Creaking noises at driver's seat when cornering

Topic number	LI91.10-P-066971
Version	2
Function group	91.10 Front seats
Date	09-05-2017
Validity	W/S205 X/C253 Seat belt buckle creaks on front seat
Reason for change	Part number of felt has changed and a template has been added.
Reason for block

Pic.1.JPG:

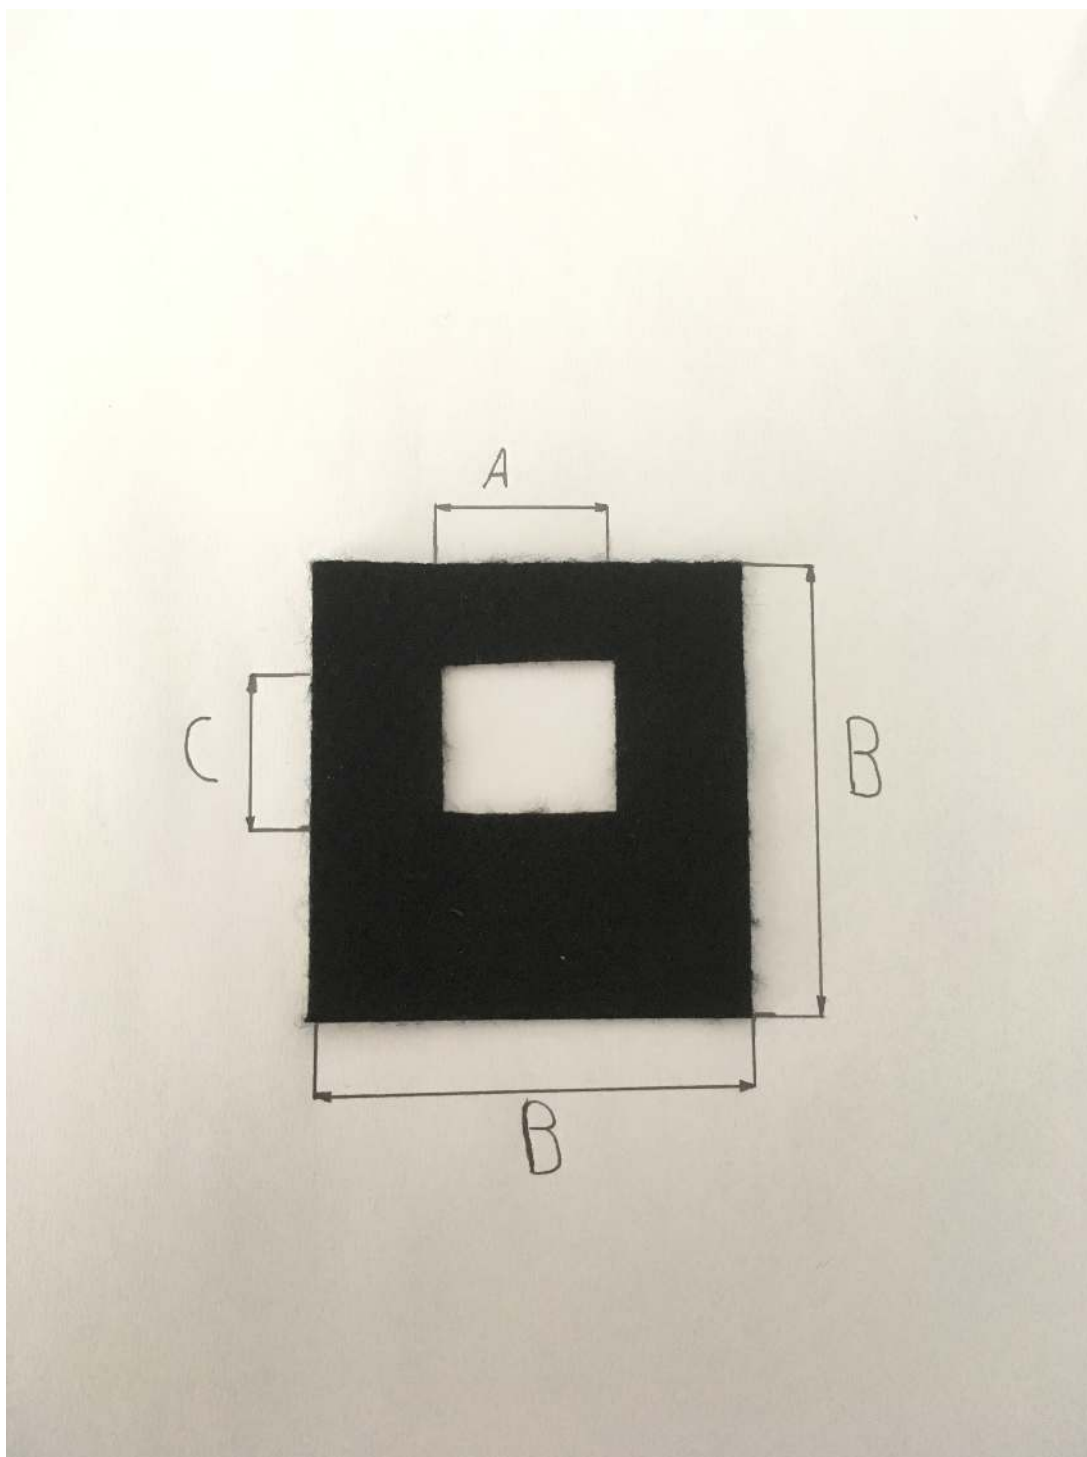
Check whether the seat belt buckle is resting on the seat cover and whether this is causing the noise. If so, line the seat belt buckles on both front seats with felt according to the template (Pic.1).

Important: The label (Pic.2, area shaded in black) on the seat belt buckle must not be lined with felt. It is not necessary to remove the seat belt buckles.

Only the felt with the part number A000 983 89 10 may be used. Any other felt will not provide a lasting remedy.

Attachments	
File	Description
Pic.1.JPG	Template with dimensions A: 25 mm B: 65 mm C: 20 mm
Pic.2.jpg	Drawing of position of felt
